**Attachment I – AMEC Earth and
Environmental Geotechnical Responses**

RESPONSES TO COMMENTS OF NUNAVUT WATER BOARD

Figure 1 Factor of Safety for Lagoon Berm (Mean Value of Soil Parameters, No Pore Water Pressure)

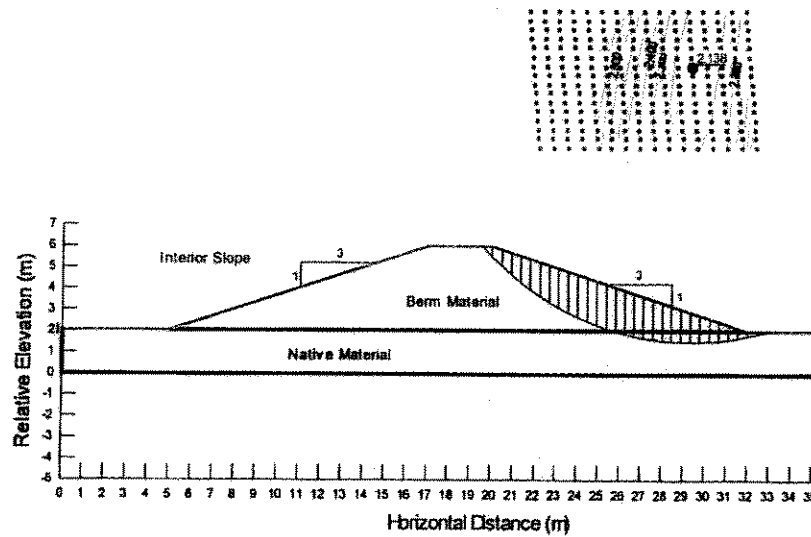
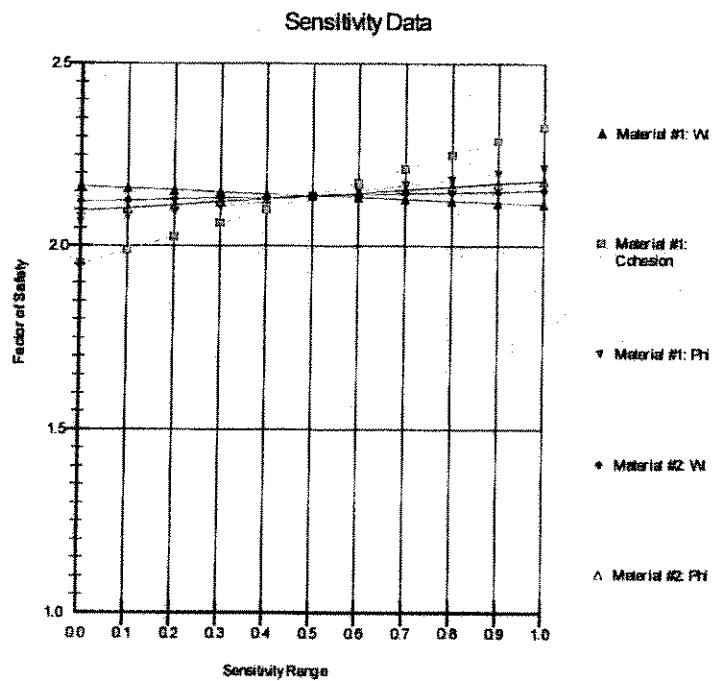
- XII. *Within Appendix D – Geotechnical Investigation of the Detailed Design Report, the factor of safety of the berm with respect to global shear failure "is expected to be greater than 1.5 on the basis that the berm is unsaturated.*

- A. *What method of analysis was completed to obtain the factor of safety?*

Figure 1 illustrates the factor of safety for the 3H:1V slope and the potential failure slip for the mean values of the soil parameters. Figure 2 presents the sensitivity plot. The strength parameters and unit weight are normalized in a range from 0 to 1. The point where three sensitivity lines are crossing, characterizes the deterministic factor of safety at the mean values for the strength parameters and the soil unit weight. The results indicate that the factor of safety against the slope failure is higher than 1.5 that is acceptable in the geotechnical practice.

Figure 4 Total Pressure Head within Berm Fill due to Seepage (Scenario 1)

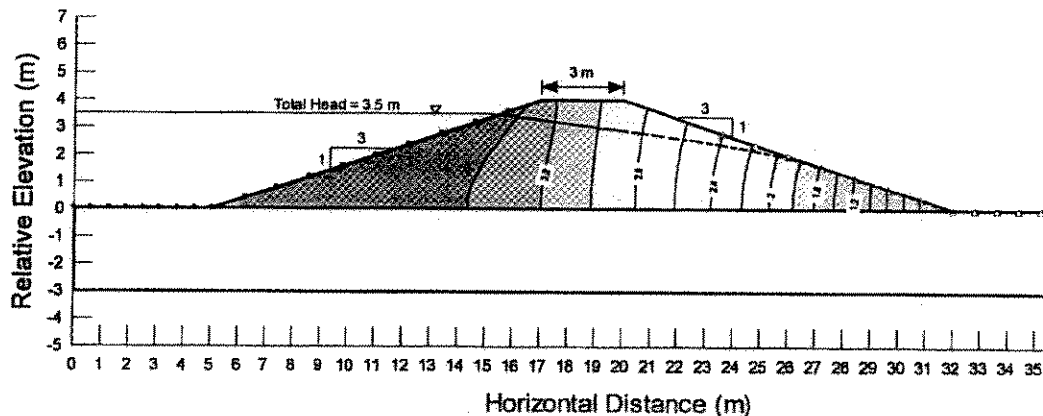
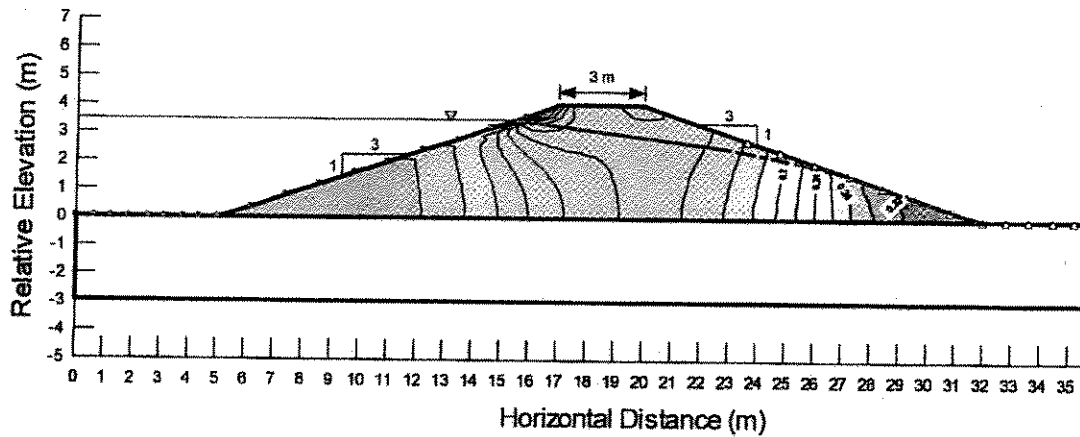
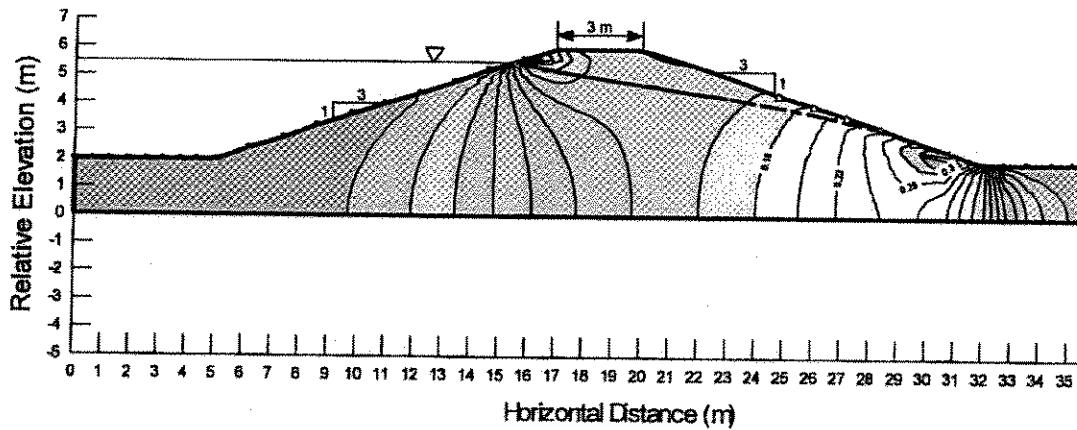
B. Has a seepage analysis been completed to assess piping potential of the soils? If so, what are the results? If not, why not?

The saturated hydraulic conductivity of the berm material (uniform sand) was assessed based on D. Swanson (1991) and the hydraulic conductivity functions for unsaturated conditions were estimated using the method, proposed by Green and Corey (1971). Figure 4 presents the total pressure head for Scenario 1 under steady flow conditions and Figure 5 shows the x-y hydraulic gradient within the proposed berm. It was found that the maximum hydraulic gradient near the toe of the exterior slope (i_{exit}) varies between 0.3 and 0.35.

The safety factor against the piping can be defined as the ratio of i_{cr} to i_{exit} where i_{cr} is the critical hydraulic gradient of berm material. The i_{cr} may be evaluated using void ratio and specific gravity of soil and generally varies from about 0.85 to 1.1 (Das 1983). The safety factor against piping was calculated to be greater than 2 which is acceptable for a short term period prior to freezing of the berm material.

Figure 6 illustrates the estimated XY gradient for Scenario 2. It was found that a 2 m thick permeable layer has an insignificant impact to the XY gradient values.

Figure 14 Temperatures in Lagoon Berm after 1 Year of Operation

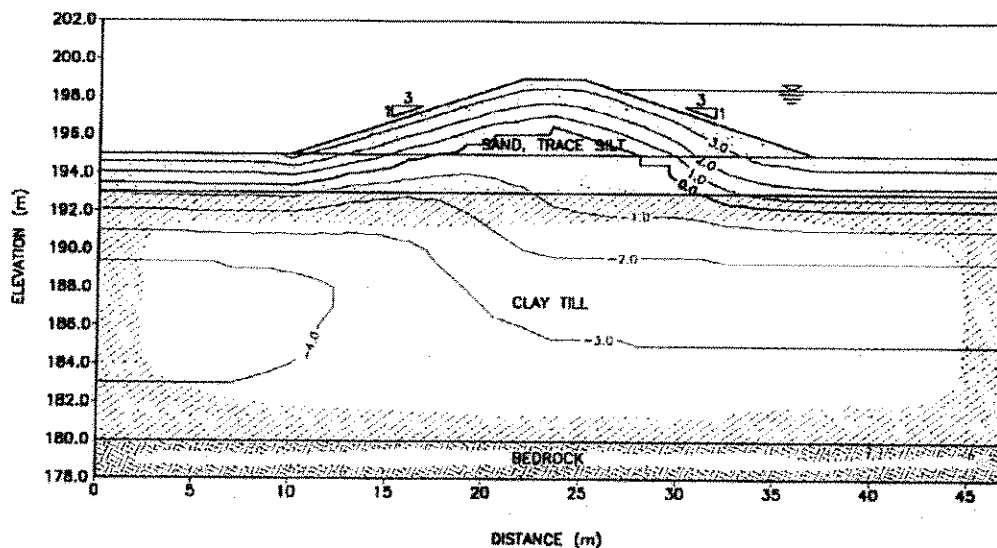
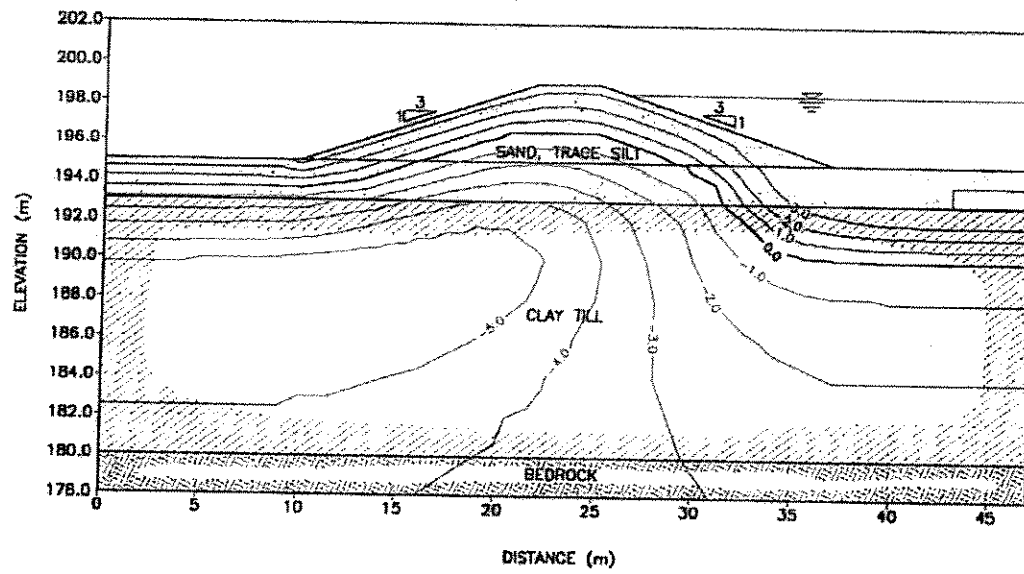
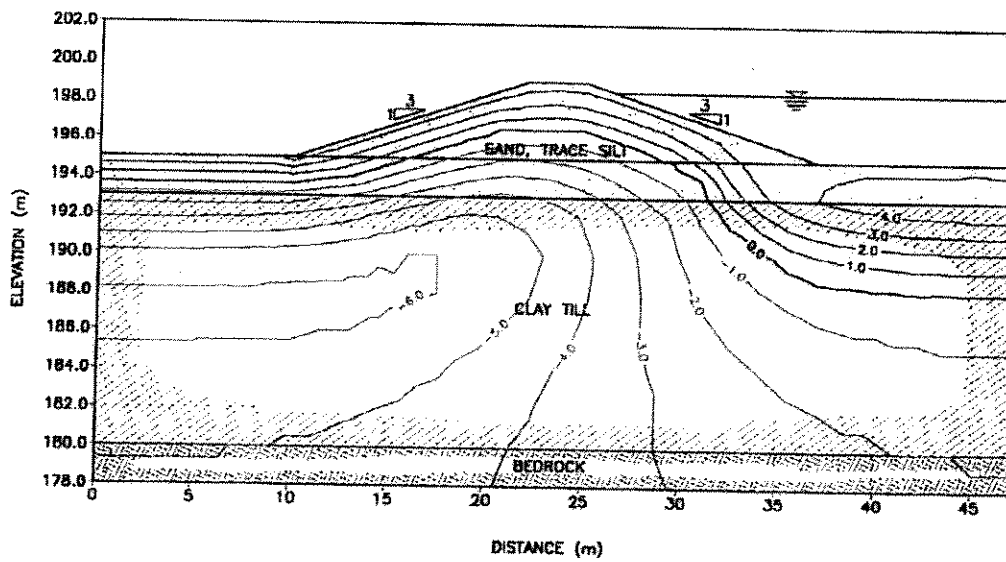
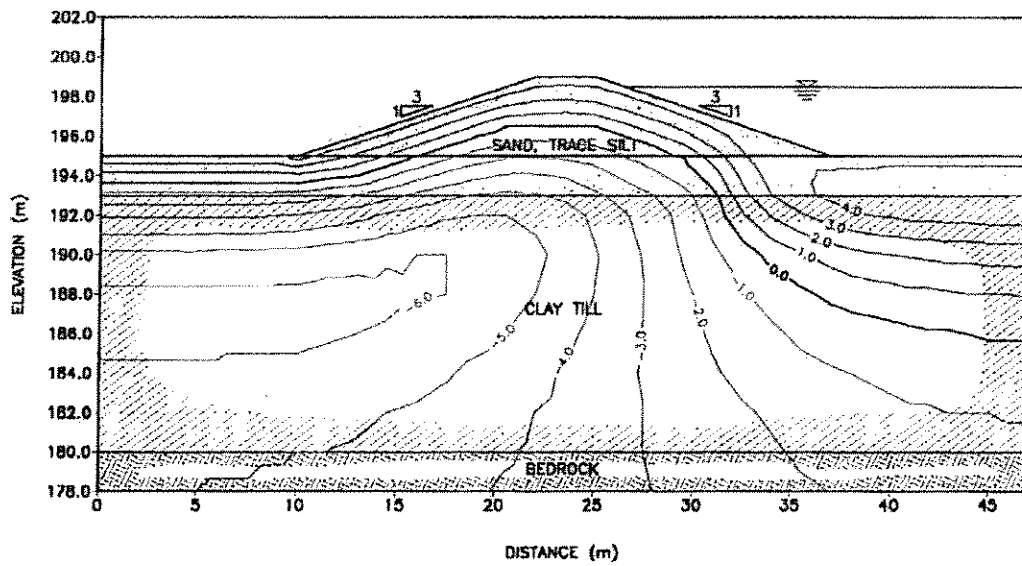
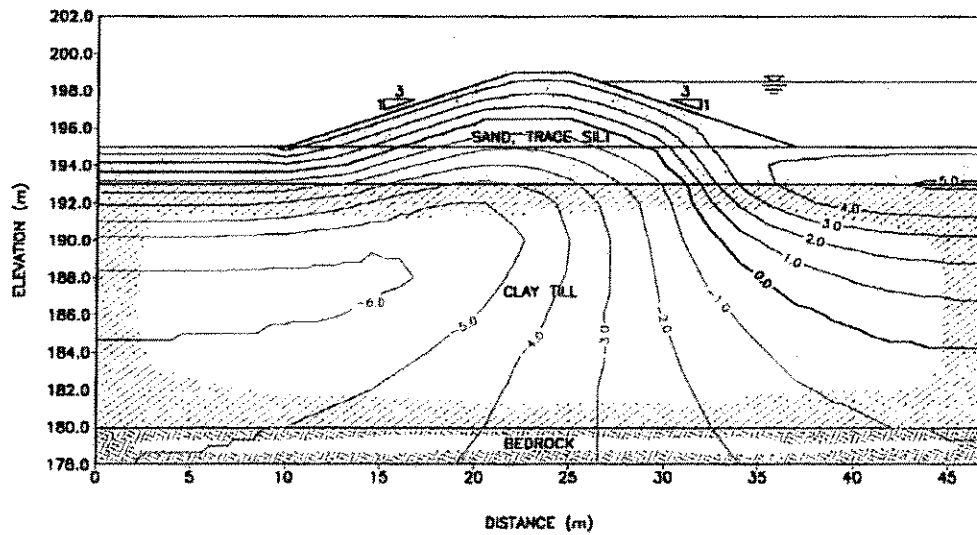
- B** *If permafrost aggregation is relied upon in the design of the landfill berm to limit seepage, does the Hamlet have an understanding of the thermal regime with time and what are these details?*

- C** *If the berms are not lined nor have permafrost aggregation, how will seepage be prevented through the active zone?*

Figure 12 shows that after the first year of berm operation, the active layer at the berm crest is about 3 m. The majority of the berm core has a temperature in a range from 0.5°C to 3°C while the ground temperature near the berm core and under the dyke is about -0.5°C. Due to the warming effect of the lagoon water, the ground temperature beyond the interior slope of the berm (impoundment area) is about one degree warmer than the ground temperature beyond the exterior slope of the berm.

Figures 13 through 16 show that no significant temperature changes were observed within and underneath the berm from the fifth to thirtieth year of the berm operation. However, it can be seen that the thickness of the unfrozen zone under the lagoon impoundment increases up to 10 m. The thickness of the active layer in the berm was estimated to be 2 m to 2.5 m.

The numerical simulation showed that a frozen core within the lagoon berm will be formed only near the berm base. Thus, a potential for the percolation of water/effluent through the berm will depend on elevation of the water level in the lagoon. If the water level will be at the elevation, shown in Figures 14 through 18, then the percolation of the water would occur. AMEC recommends that a geomembrane be installed in the lagoon berm for seepage protection. A typical section for layout of the liner is provided in Figure 19. The cut-off trench, at least 2.5 m deep, should be excavated at a position of the interior slope crest. The liner should be placed vertically in the cut-off trench and then backfilled with compacted clayey material or grouted. The liner curtain should then follow the ground surface to the toe of the interior slope and then cover the interior slope to elevation higher than the expected maximum water level, as shown in Figure 19. The liner should be covered with a 0.5 m thick riprap layer. An alternative liner option is shown in Figure 20. It is understood that the constructability of the alternative option is more complex however the liner is nearly half as wide. The alternative option suggests covering the interior berm slope with a 0.5 m thick riprap layer to protect the slope against thermal and wave erosion.

Figure 19 Proposed Layout of HDPE Liner (Option 1)

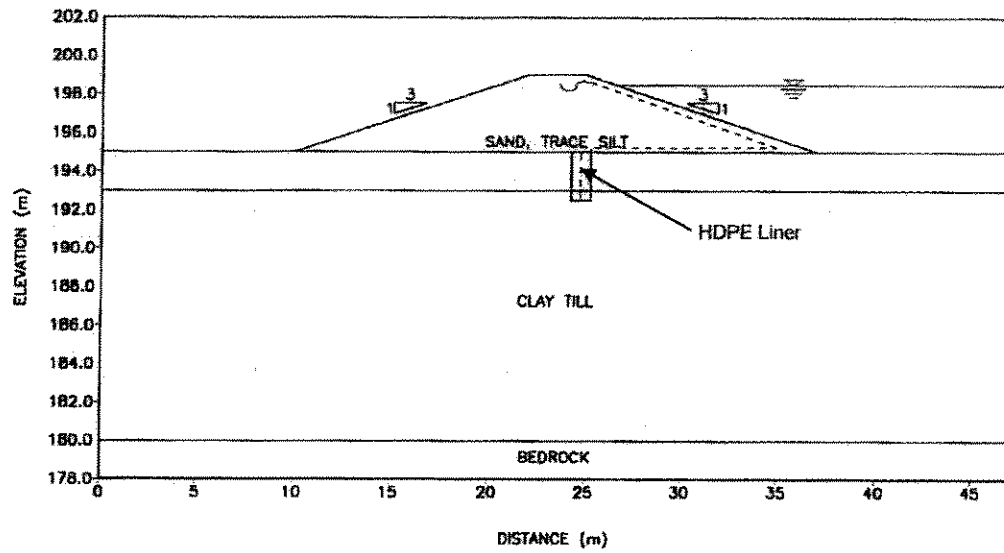
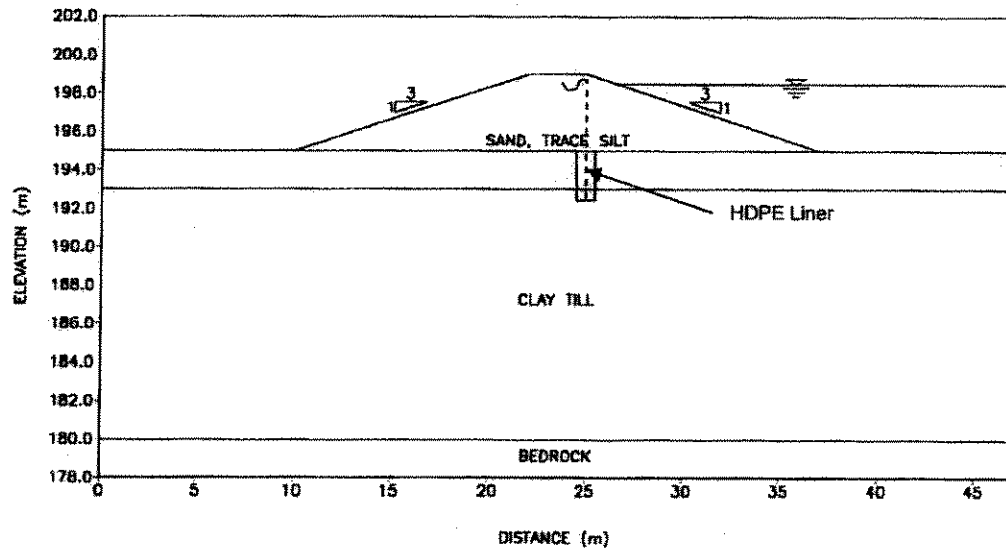
4. *Will the geomembrane be keyed into the foundation? If so, what are the design details?*

5. *Will the geomembrane be anchored within the berm? If so, what are the design details and engineering analysis?*

The geomembrane will be keyed into the foundation (see Figure 19 & 20). Also see Nuna Burnside response.

Please see Figure 19 & 20. Also see Nuna Burnside response.
